#### BRADBURY PLACE TOWNHOMES A PORTION OF SECTION 3, TOWNSHIP 19N, RANGE 04 E, W.M. CITY OF PUYALLUP, PIERCE COUNTY, WASHINGTON 1 INCH = 50 FEET (22"x34")1 INCH = 100 FEET (11"x17")FOUND BRASS PIN IN CONCRETE, -SEC. 3, TWP. 19N, RGN. 4E, W.M. INCASED 1.6' DOWN AT THE NORTHWEST SEC. CORNER OF SEC. 3, TWP. 19N, RGN. 4E, W.M. VISITED 12-22-20 CALCULATED FROM ROS 30' ROAD EASEMENT AS SHOWN ON SP REC. NO.8101070262 12"PVC E IE 397.57 12"PVC W IE 397.49 12"PVC S IE 397.51 LEGAL DESCRIPTION SITE BENCH MARK 1— SET HUB AND MAG EL=406.33 (NAVD 88) PARCELS A AND B, PIERCE COUNTY LOT COMBINATION RECORDED UNDER RECORDING NO. 200104110218, RECORDS OF PIERCE COUNTY, WASHINGTON. SITUATE IN THE COUNTY OF PIERCE, STATE OF WASHINGTON. BASIS OF BEARING HELD BEARING OF SOUTH 87°44'39" EAST ALONG THE CENTER LINE OF SOUTH 96TH STREET, BETWEEN CITY OF TACOMA POINT RIM=417.44 6"PVC W/CAP DIRECTED TO CB NEAR PROPERTY LINE NUMBERS 910 AND 720. WASHINGTON STATE PLANE, NAD83/91, SOUTH ZONE CB 2 RIM=410.95 8"PVC E IE 406.55 ₹. 12"PVC N IE 406.49₹ SURVEYOR'S NOTES 1) THE MONUMENT CONTROL SHOWN FOR THIS SITE WAS ACCOMPLISHED BY FIELD TRAVERSE UTILIZING A THREE (3) SECOND THEODOLITE WITH INTEGRAL ELECTRONIC DISTA

SHEET TITLE: AISLE B PLAN AND PROFILE
CLIENT: BRADBURY PLACE LLC
7809 PACIFIC AVE
TACOMA, WA 98408

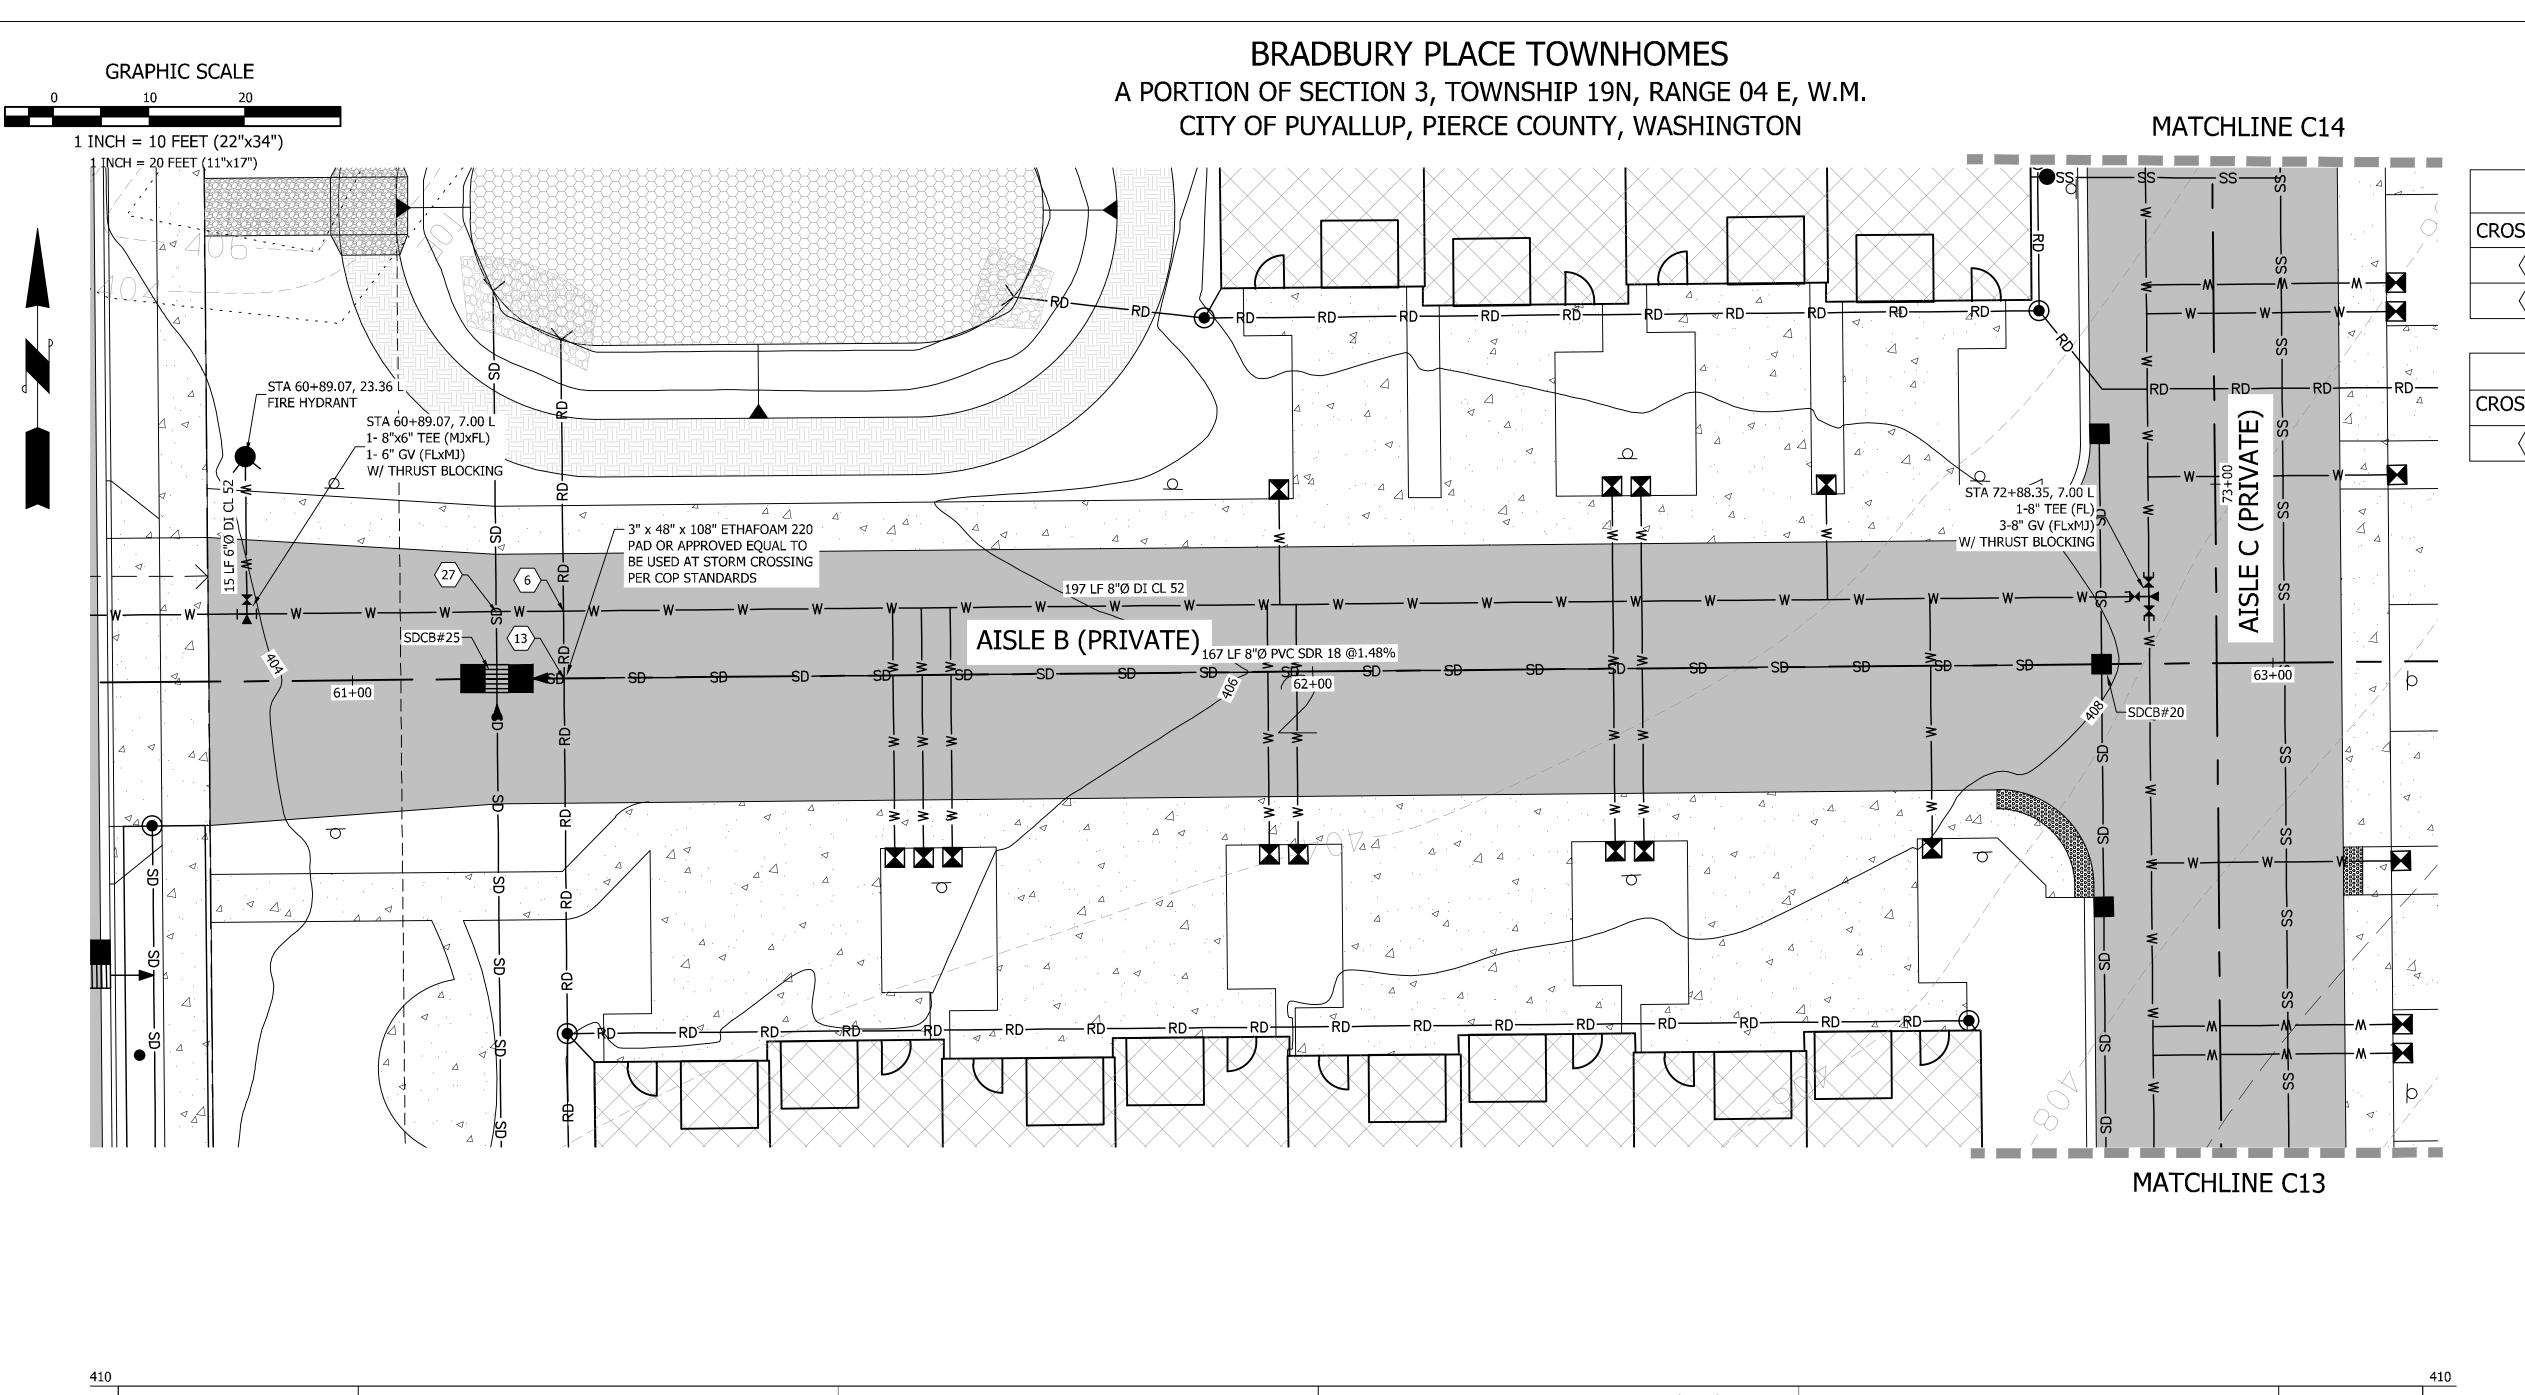
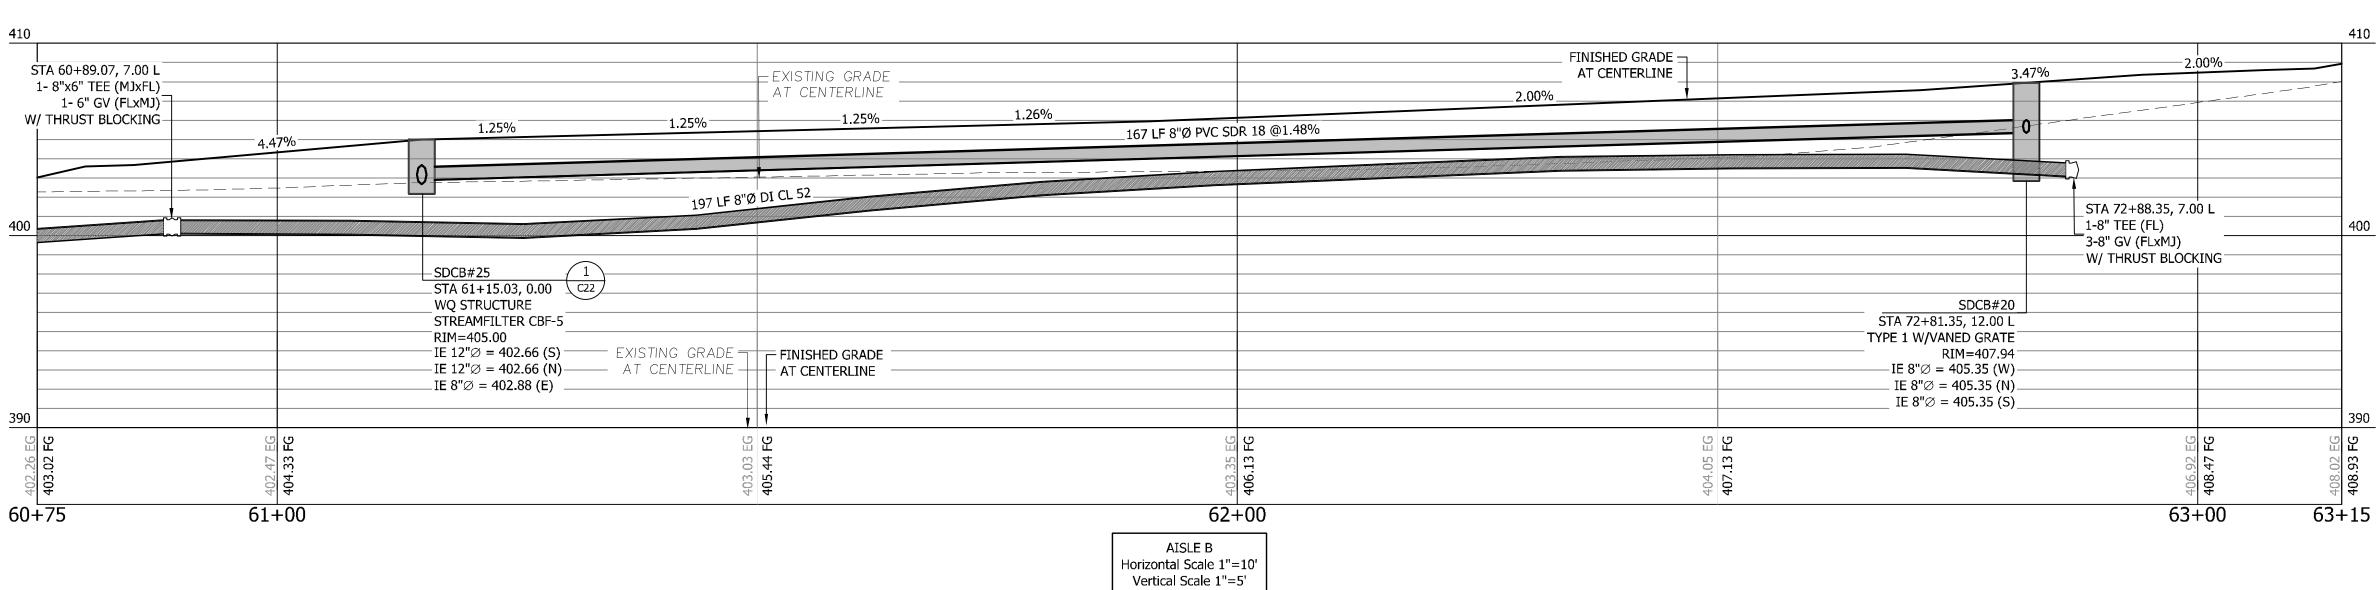
The matchlines provided do not line up with matchlines from other sheets. Revise the matchlines for consistency and accuracy in resubmittal (typ.). [Civils, pg. 15]

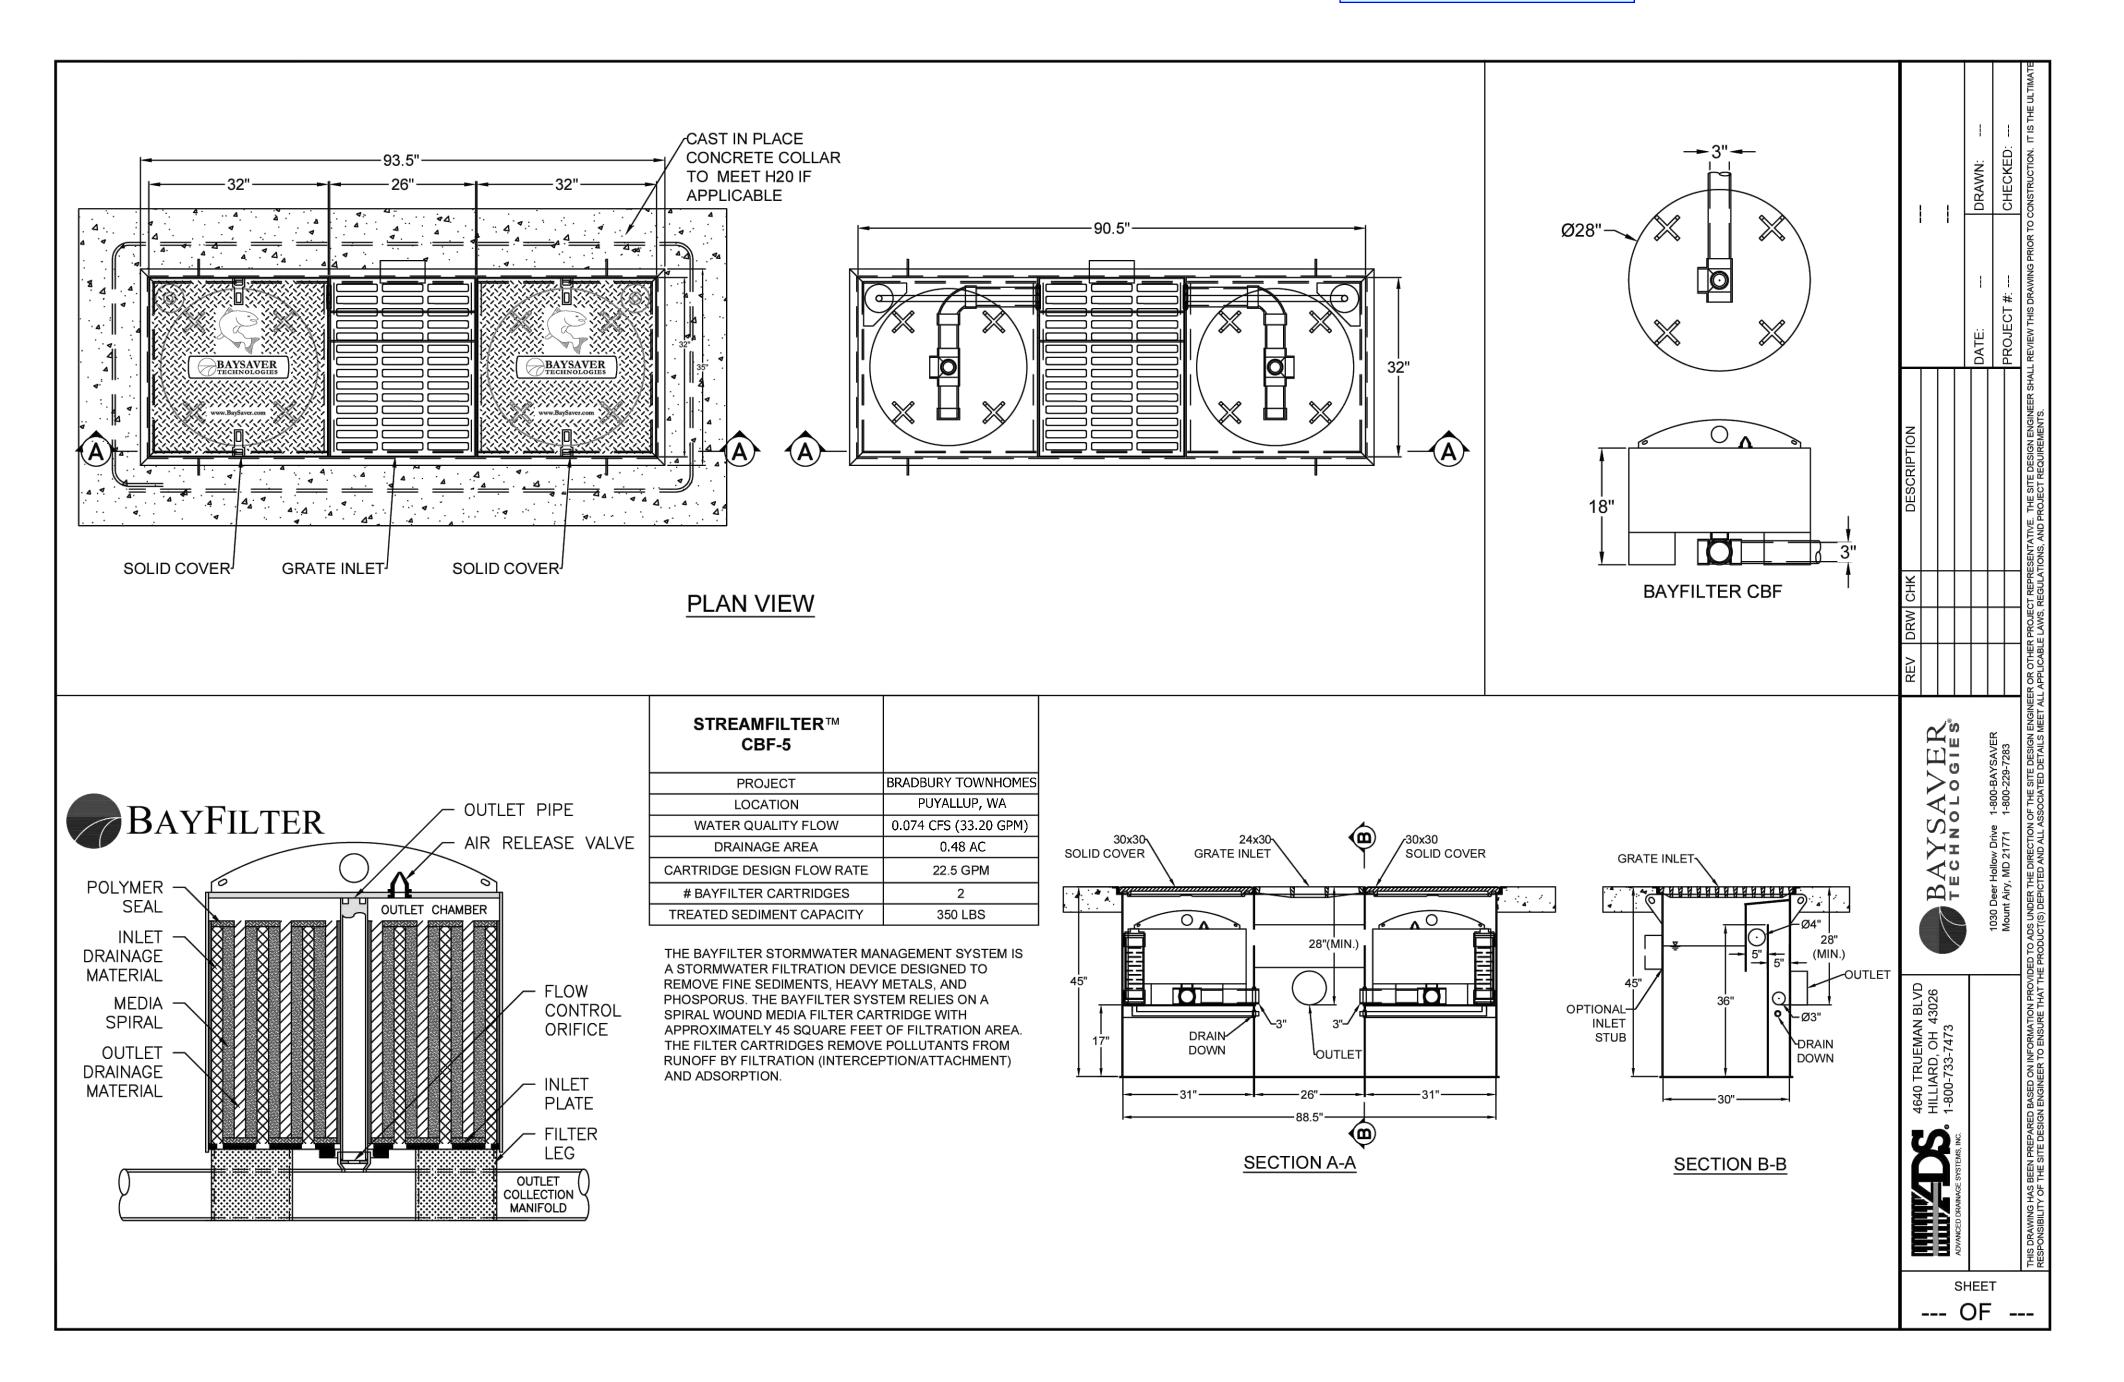
Provide confirmation from manufacturer that the water quality device is sized correctly for the runoff intake. [Civils, pg. 22]

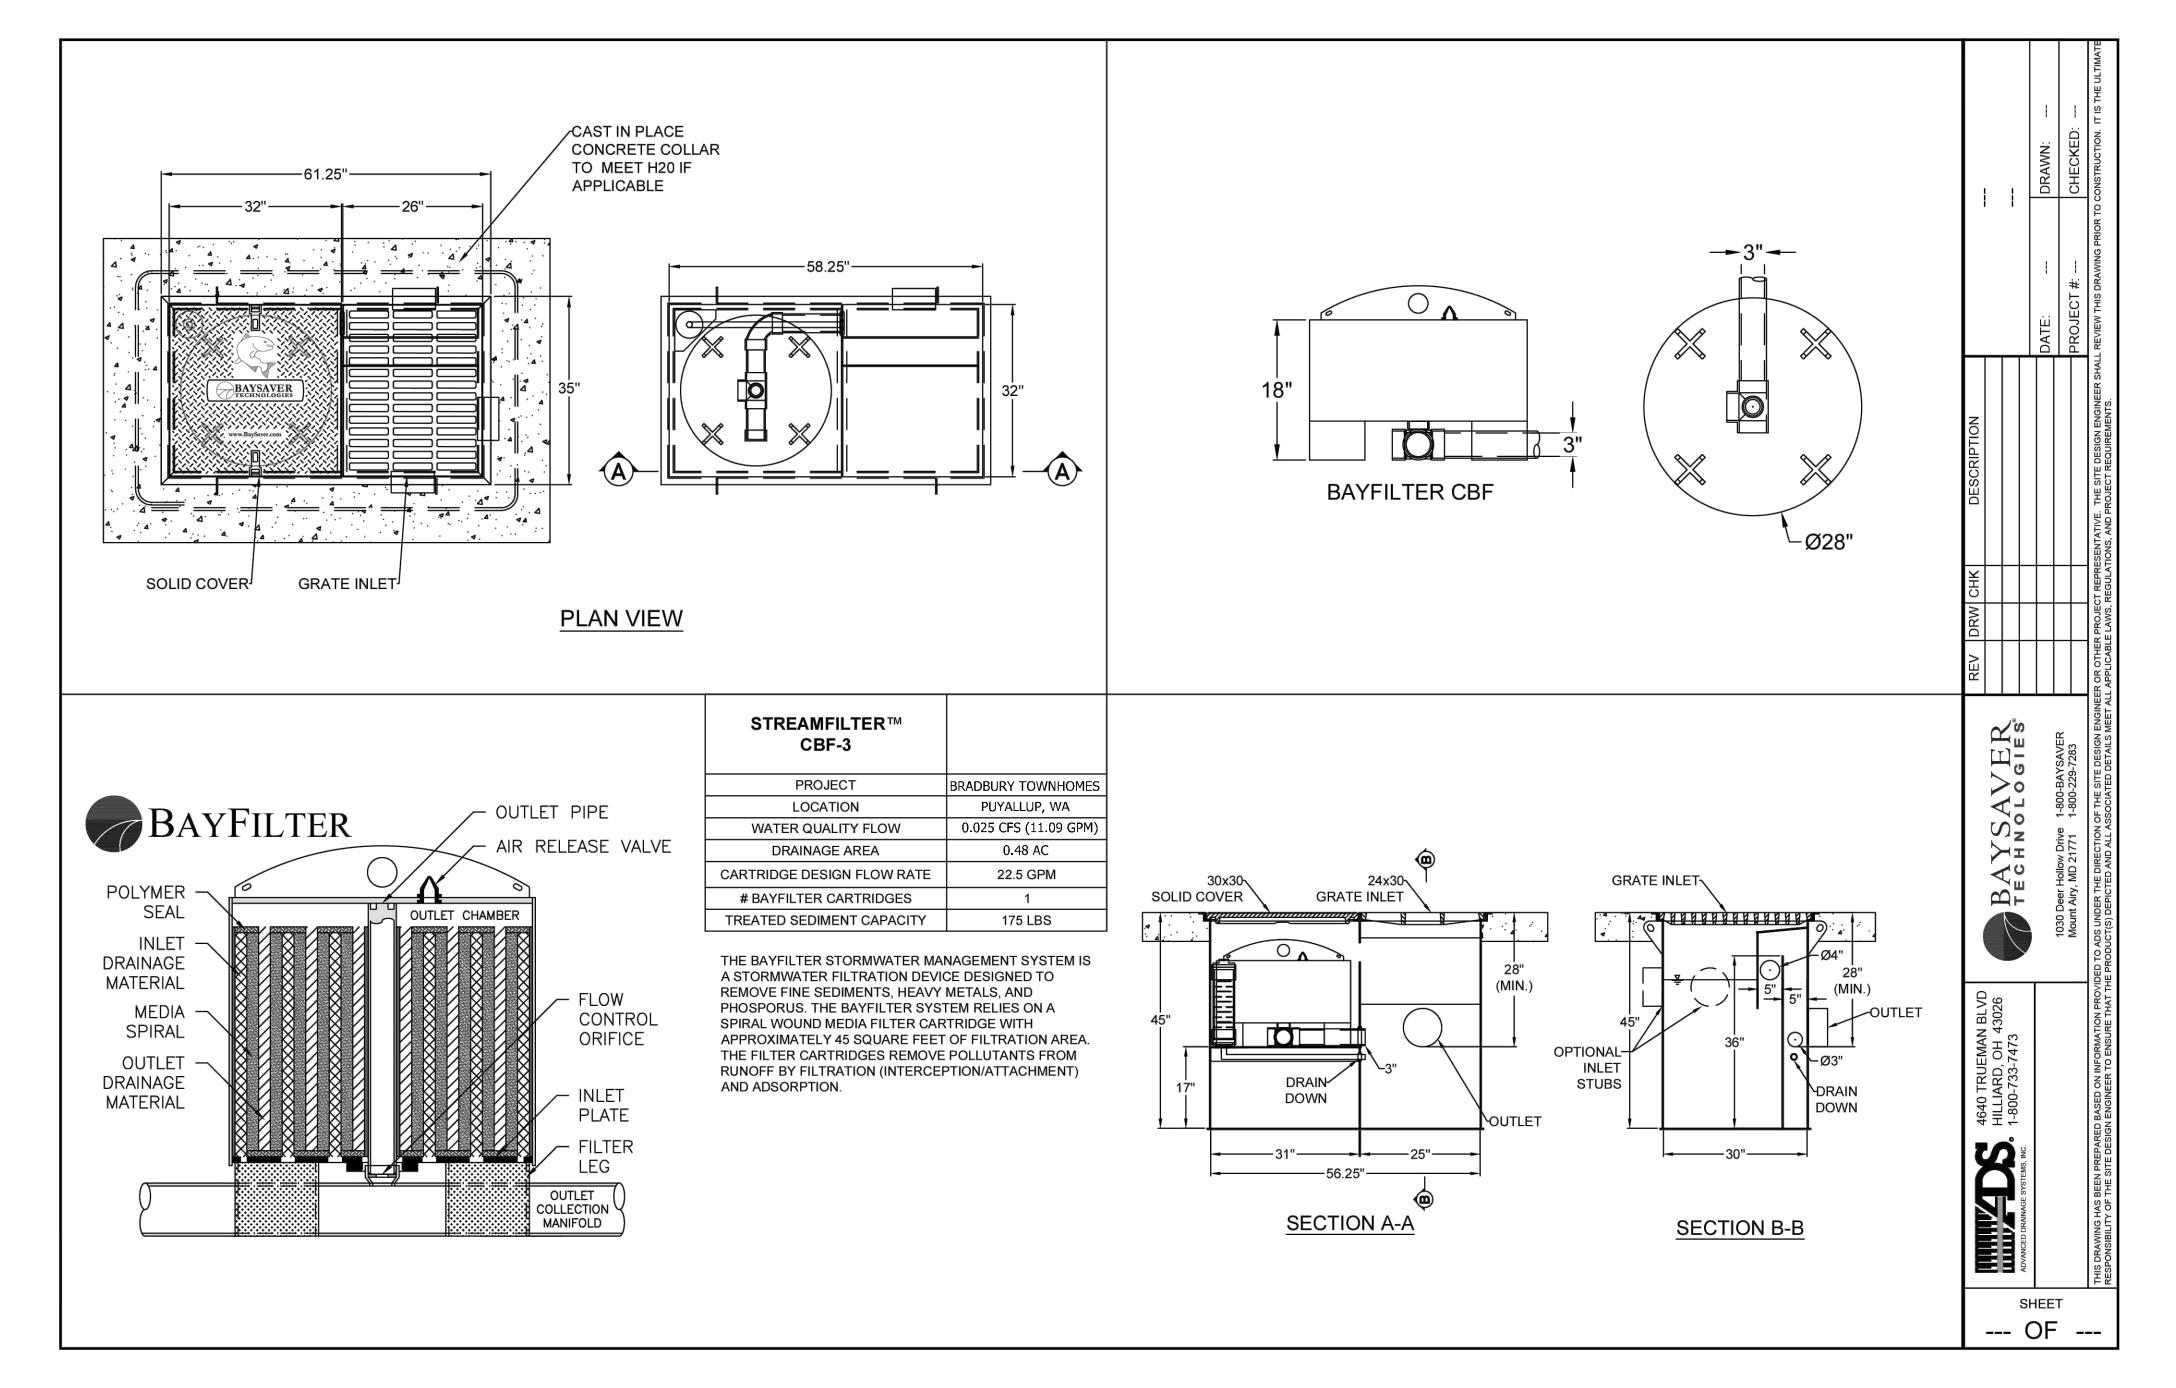
Provide confirmation from manufacturer that the water quality device is sized correctly for the runoff intake. [Civils, pg. 23]
